SUBJECT: Nine Mile Point Nuclear Station
Unit No. 2; Docket No. 50-410

Response to Request for Additional Information Regarding Nine Mile Point Nuclear Station, Unit No. 2 – Re: The License Amendment Request for Extended Power Uprate Operation (TAC No. ME1476)

RESPONSE TO REQUEST FOR ADDITIONAL INFORMATION REGARDING LICENSE AMENDMENT REQUEST FOR EXTENDED POWER UPRATE OPERATION (NON-PROPRIETARY)

Figure D4-1

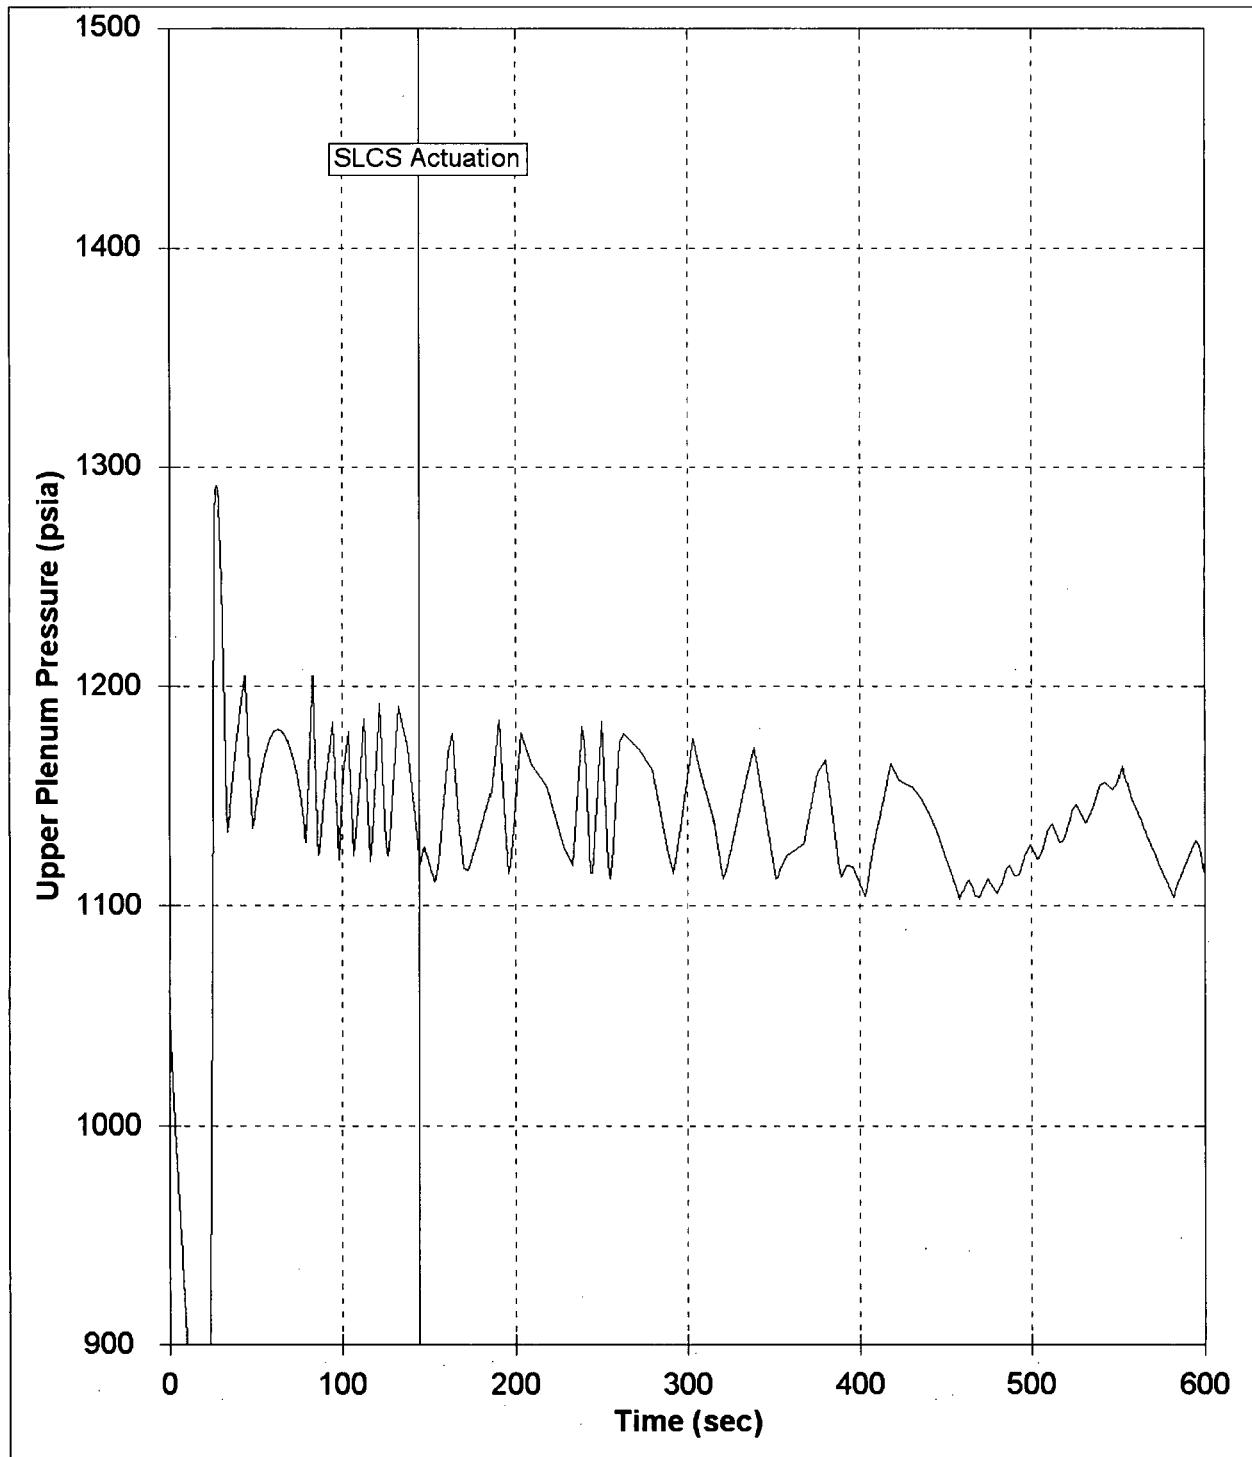
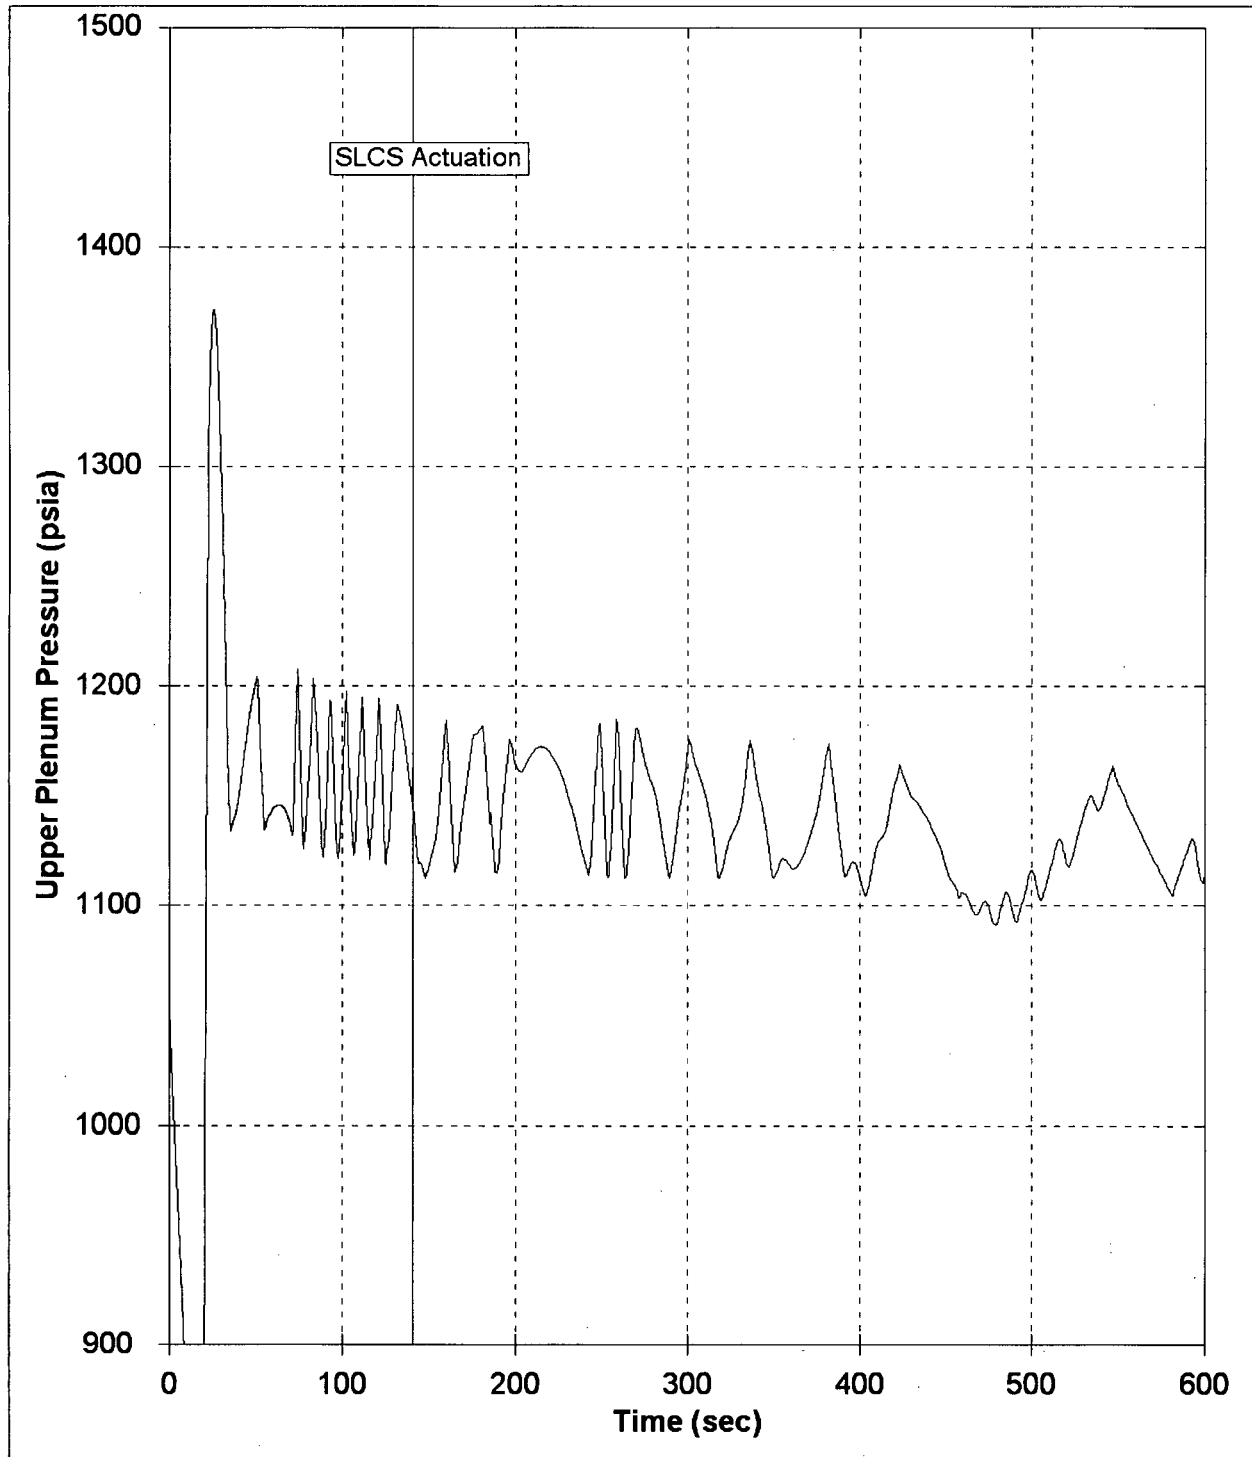
Provide plots for the limiting ATWS event (for both EPU and current licensed thermal power (CLTP) conditions) consistent with Tables 2.8-5 and 2.8-6 of NEDC-33351P, which show the bottom vessel pressure and indicate when the Standby Liquid Control (SLC) System starts injecting.

PRFO ATWS – CLTP EOC – NMP2

PRFO ATWS – EPU EOC – NMP2
